REZONING  
SITE PLAN  
FOR  
DR. LOUIS TOTTH

**PETITION NO:** Z-21

**ZONING COMMENTS:**

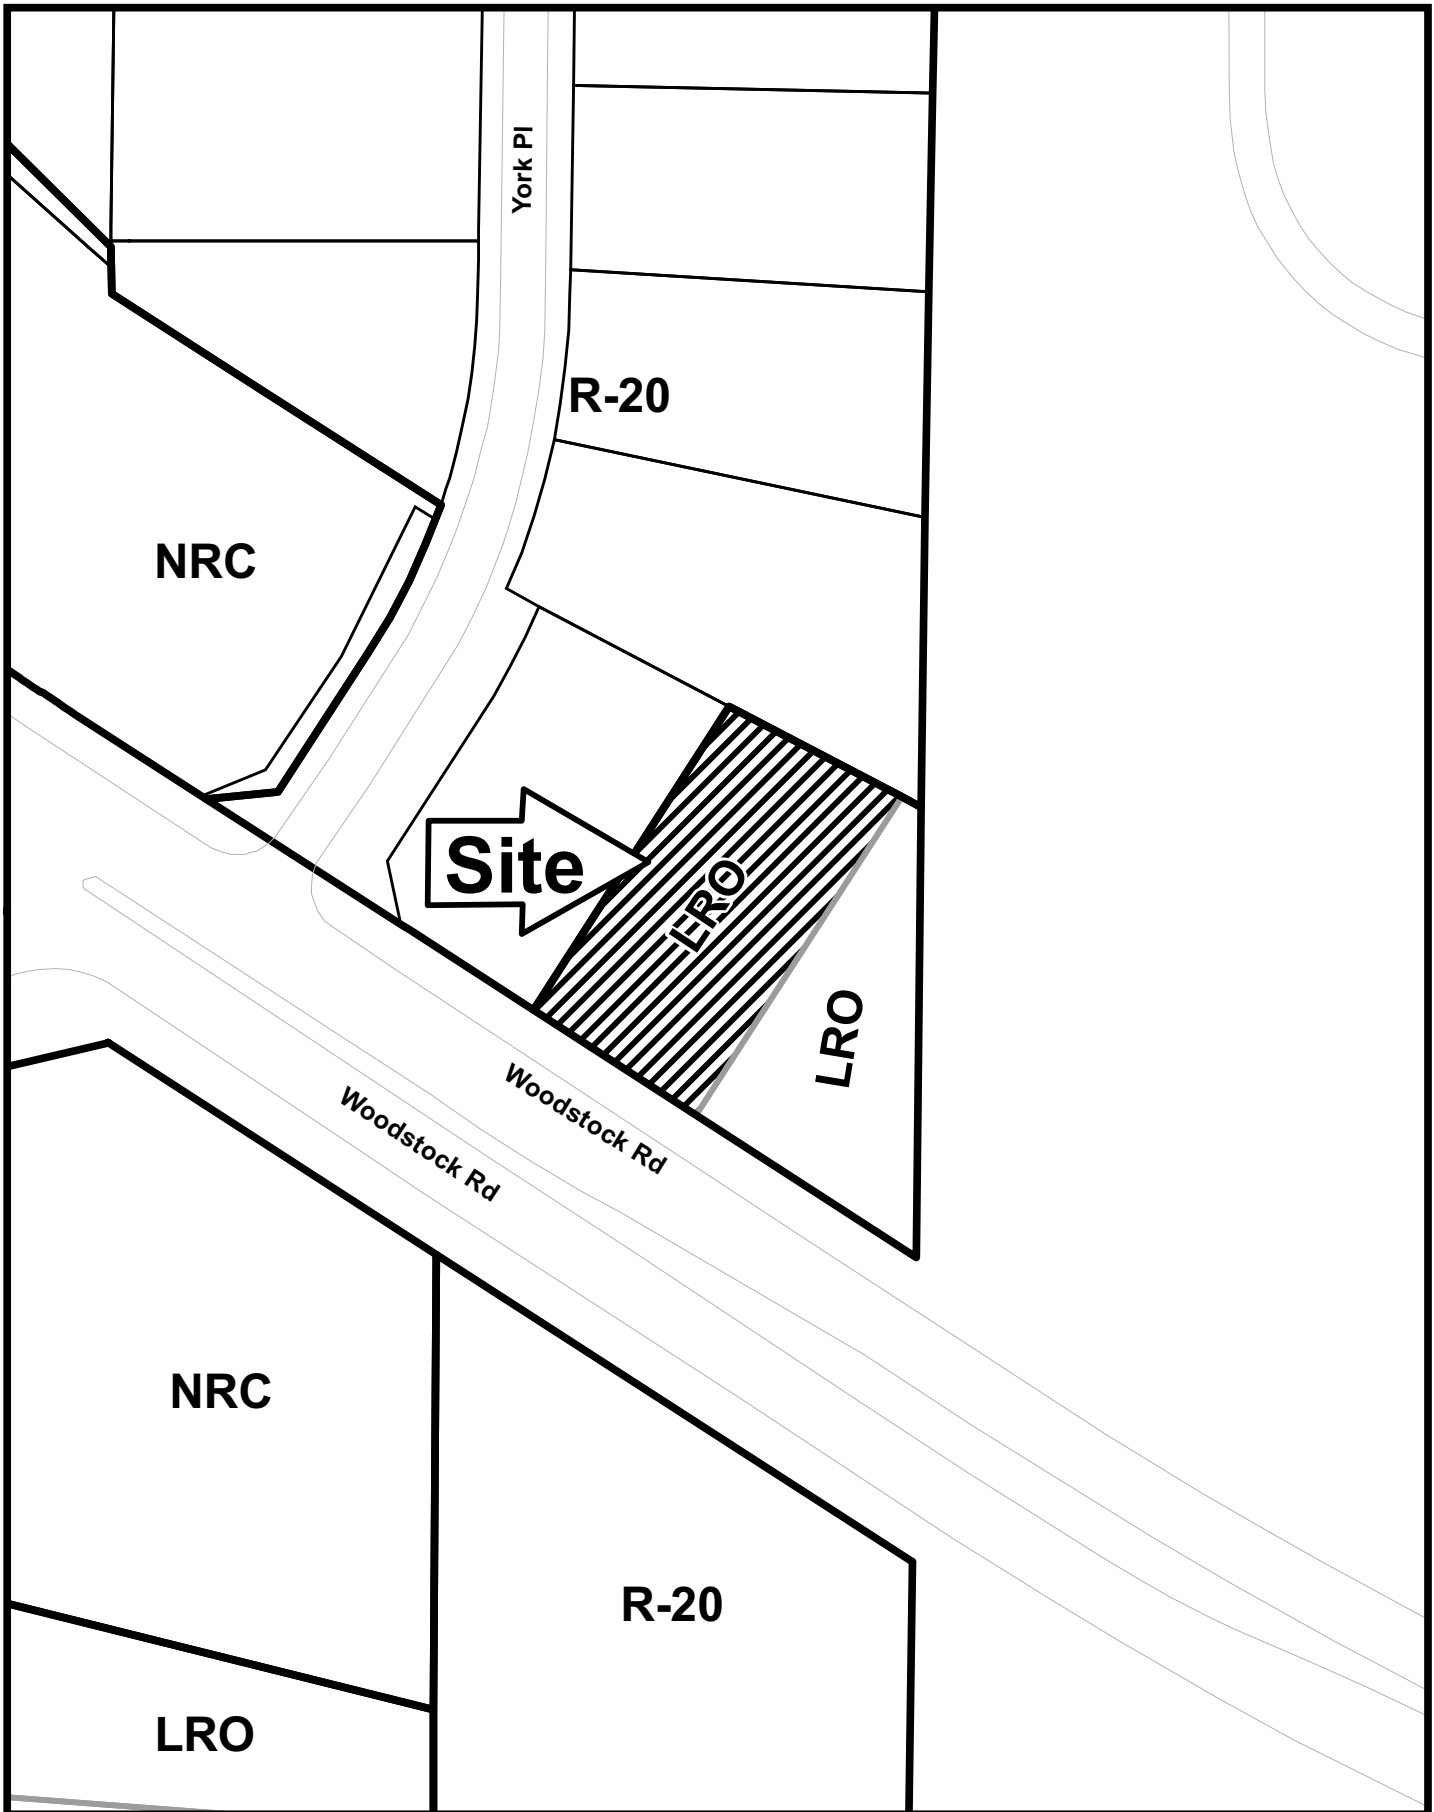
- No Stormwater controls shown \_\_\_\_\_
- Copy of survey is not current – Additional comments may be forthcoming when current site conditions are exposed.
- No site improvements showing on exhibit.

1. No site improvements are proposed at this time. Any future improvements must meet current Stormwater Management requirements.
